# IOWA CITY HISTORIC PRESERVATION COMMISSION

# Thursday, November 14, 2019

Historic Review for 225 North Gilbert Street

# Historic Review for 229 North Gilbert Street

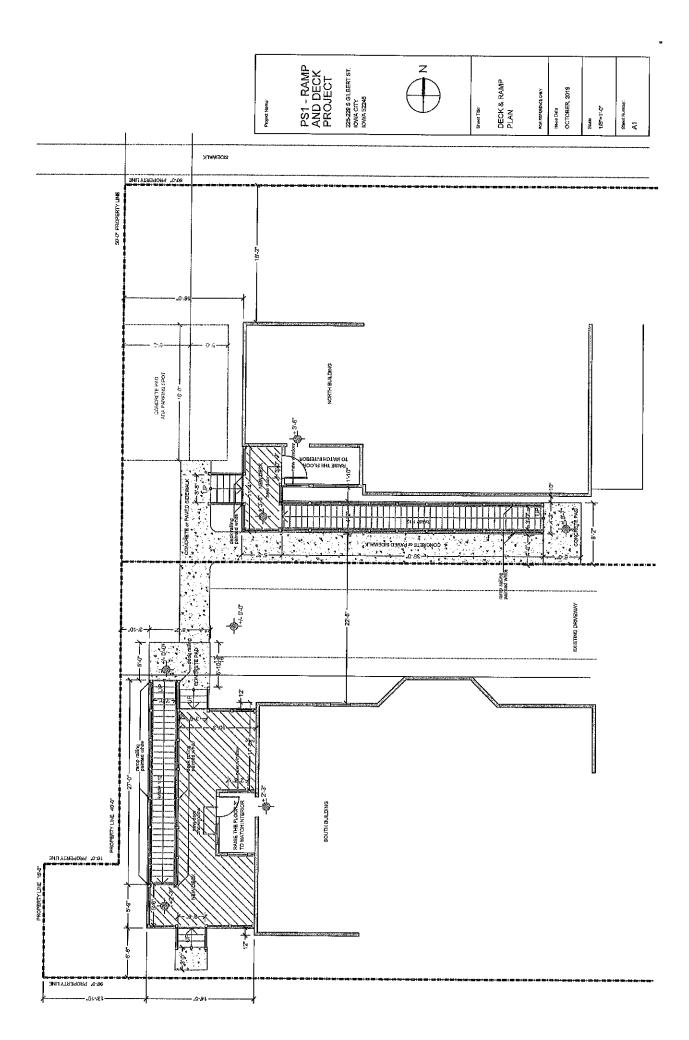
The applicant is proposing to relocate the entry door to the rear porch, and changing the locations of windows as well to accommodate a new deck and entry ramp that is part of a separate application. The project drawings show a single window in each of the north and south walls (one replacing the existing north-facing door opening) and a single window and door in the west wall. The applicant intends to use reclaimed windows matching the existing south window and a reclaimed door.

The porch currently includes a north-facing entry door and two windows on the south wall, one of which is missing. The west-facing wall has no openings. The lower half of all walls on the enclosed porch exhibit a traditional railing with beadboard siding instead of an open baluster or lap siding to match the house. The beadboard was likely installed when the porch was enclosed in the 1940s or before. The west wall likely had windows when the porch was enclosed. They were then removed and then the upper half of the wall was infilled with modern sheet material (plywood, hardboard or similar).

In Staff's opinion, changing the location of the entry door to the porch is an acceptable change that on its own will not impact the historic character of the house. The new location will increase the ease of access to the house. Because this is an enclosed porch, staff does feel that the location and quantity of the windows should be revised from the original application in order to meet the guidelines' requirement that relocated openings should not detract from the overall fenestration pattern.

As an enclosed porch with an original railing, historic beadboard cladding, and historic storm windows, the porch wall above the railing would have consisted of ganged storm windows when it was originally enclosed. Staff recommends maintaining that window patterning in the new project instead of treating the porch

enclosure like a wall with fewer openings centered on each wall. If this historic pattern of openings is retained the need to create a new trim condition in this location in prevented. The new door will need a minimal amount of trim to hide its frame. Matching the new windows to the existing south window is appropriate. A door or door product has not been submitted for approval. Staff recommends approval of the project with revisions to the window layout shown on the drawings.

The plan is revised to show two windows matching the existing filling the space between column and wall on the north and south elevations and a door and at least two windows filling the space between columns on the west wall.

Door product is approved by staff.

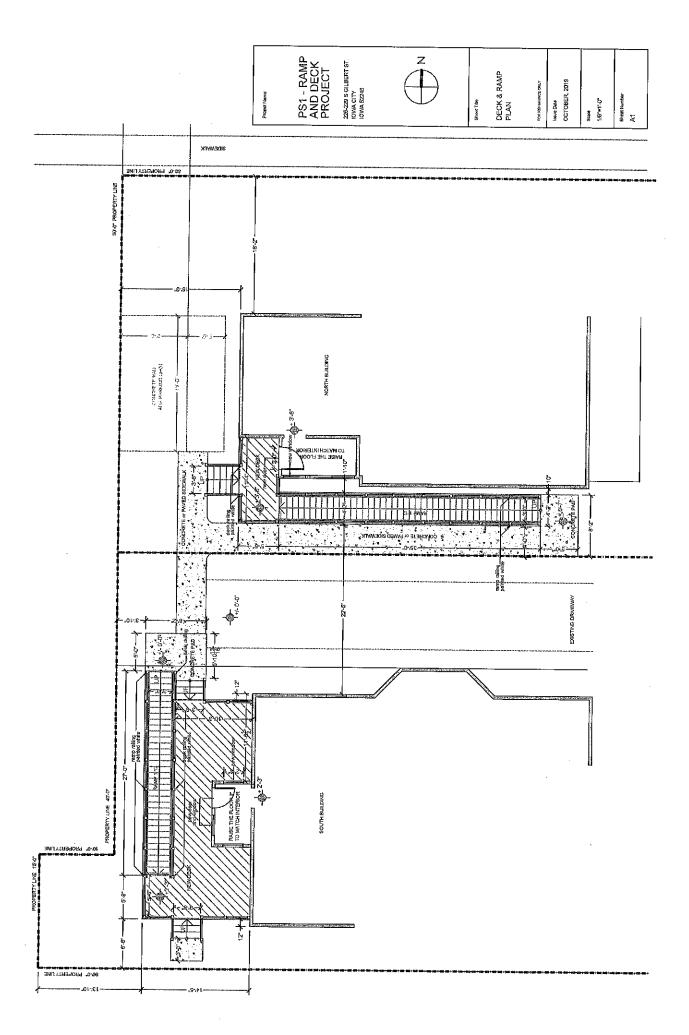
The applicant is proposing to relocate the entry door to the rear porch, replacing it with a window to accommodate a new deck and entry ramp that is part of a separate application. As a part of the project, the cellar door may also be removed since it would be covered by the deck. The passage door from the porch will be moved to the west wall of the enclosed porch where a window currently exists. Its original position on the south wall will be replaced by the relocated window. All siding and trim will be reused. If the cellar door is removed, the opening will be infilled with concrete block matching the original foundation.

The porch currently includes a north-facing entry door and two windows on the south wall, one of which is missing. The west-facing wall has no openings. The lower half of all walls on the enclosed porch exhibit a traditional railing with beadboard siding instead of an open baluster or lap siding to match the house. The beadboard was likely installed when the porch was enclosed in the 1940s or before. The west wall likely had windows when the porch was enclosed. They were then removed and then the upper half of the wall was infilled with modern sheet material (plywood, hardboard or similar).

In Staff's opinion, changing the location of the entry door to the porch is an acceptable change that on its own will not impact the historic character of the house. The new location will increase the ease of access to the house. Unlike the applicant's other property, the enclosed porch here does not exhibit some of the same historical details. This, in combination with the existing synthetic siding, reduces the need for historic detailing as part of the project. The use of the existing window, door, siding, and trim in the new configuration is appropriate until such a time as the synthetic siding is removed and the window configuration in particular is revisited. The removal of the cellar door, if necessary as part of the project,

could also be approved. The basement is accessed from the interior of the house and the cellar door will be obscured by the new deck. If possible, the cellar door could also be retained and covered by the deck. Staff recommends approval of the project

Move to approve a Certificate of Appropriateness for the project at 229 North Gilbert Street as presented in the application and staff report.
